Production Changes in 1942 Models

The following pages contain complete listings of all major changes—involving changes in circuit, part numbers or anything of interest to the serviceman—in Philco Models current at the time of printing. These are all the changes which have been made since the date of publication of the last printing of the Philco Service Bulletin on each model; the number of the Bulletin is given in each case for reference.

MODEL 42-718, CODE 121 Radio Service Bulletin No. 389

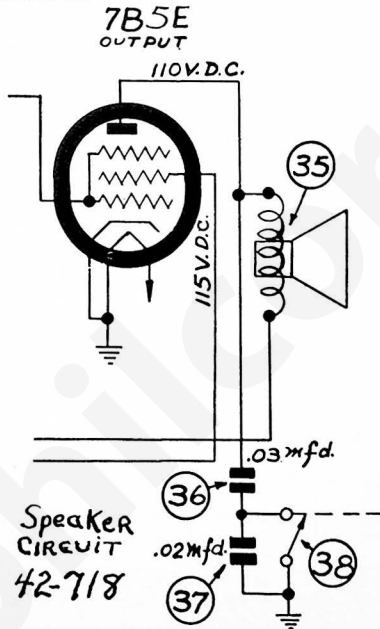
Beginning with run 2, the speaker (35) was changed from Part No. 36-1520-4 to Part No. 36-1576. The new speaker is a permanent type and the wiring is different from that shown on the diagram for speaker Part No. 36-1520-4. The wiring for the new speaker is shown below.

Output transformer (34) Part No. 32-8106 is also removed when the permanent speaker Part No. 36-1576 is installed.

The voice coil in the new speaker takes the place of the output transformer.

MODEL 42-788, CODE 121 Radio Service Bulletin No. 403

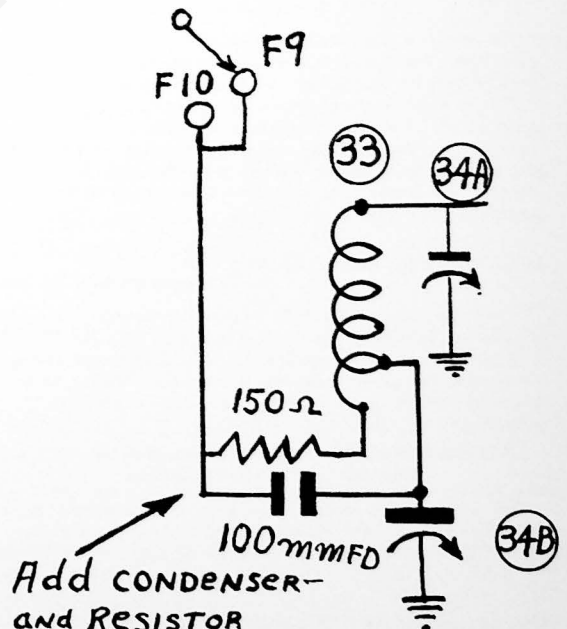
If trouble is experienced in padding the 22 M.C. normal tuning range (compensator 38A), the installation of a 150 ohm resistor Part No. 33-115339 and a 100 mmfd. condenser will improve the operation. These parts are installed in the circuit as shown in the diagram below.

HUM REDUCTION

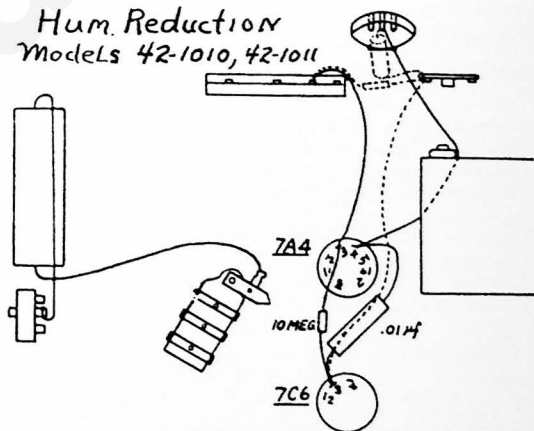
To reduce hum, electrolytic condenser (32)-(32A) 8-8 mfd., 475 volts Part No. 30-2535 was changed to 8-24 mfd., 475 volts Part No. 30-2538. The 8 mfd. section is connected in the circuit position (32) and the 24 mfd. section in position (32A). Chassis with this change are marked run 4. In some receivers prior to this change an 18 mfd. condenser was connected in parallel with (32A).

Remove the .01 mfd. condenser, Part No. 30-4572, which is connected to the center tap of the volume control to the terminal on the wiring panel right below it. Also, remove the 10 meg. resistor which is wired to this terminal and to the second terminal of the bias resistor 82.

Remove the wire which formerly connected the resistor and condenser to the #3 terminal of the 7C6 tube socket.

Connect the center terminal of the volume control to the dummy #4 terminal of the 7A4 tube socket. Connect the second terminal of the resistor 82 to the dummy #3 terminal of the 7A4 tube socket. Both of these leads must be dressed close to the sub base. Follow the layout shown in the accompanying diagram.

Connect the .01 mfd. condenser, Part No. 30-4572, from the #3 terminal of the 7C6 tube to the #4 terminal of the 7A4 tube. Connect the 10 meg. resistor from the #3 terminal of the 7C6 tube to the #3 terminal of the 7A4 tube.

In the diagram, the parts and wires indicated by the dotted lines are to be removed. The 10 meg. resistor and the .01 mfd. condensers are shown in their new location. The location of the 18 mfd. condenser and the wiring connections are also shown.

TONE CONTROL CIRCUIT 42-1016

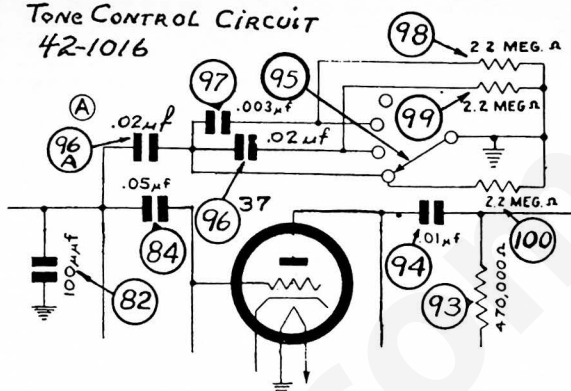
RUN 4 TONE CONTROL CHANGE

See diagram below for wiring

Remove (96) condenser, Part No. 30-4591, and replace with a .02 mfd. 400 volt, Part No. 30-4516 condenser.

Remove condenser (96A) .01 mfd., Part No. 30-4572, from its present location and connect a wire from switch contact to terminal panel lug. Change value of 96A to a .02 mfd., 400 volt Part No. 30-4516 condenser and reconnect from the plate contact of the XXFM tube socket to the No. 6 contact of 6L6G tube (Dummy Lug).

Remove the wire from the grid contact of the 37 tube socket which comes from the treble tone control wiring panel. Reconnect this wire to No. 6 contact (Dummy Lug) of the 6L6G tube socket next to the XXFM tube. Connect a 10 mfd., 25 volt condenser Part No. 30-2500 from the cathode of the 7C6 tube to ground.
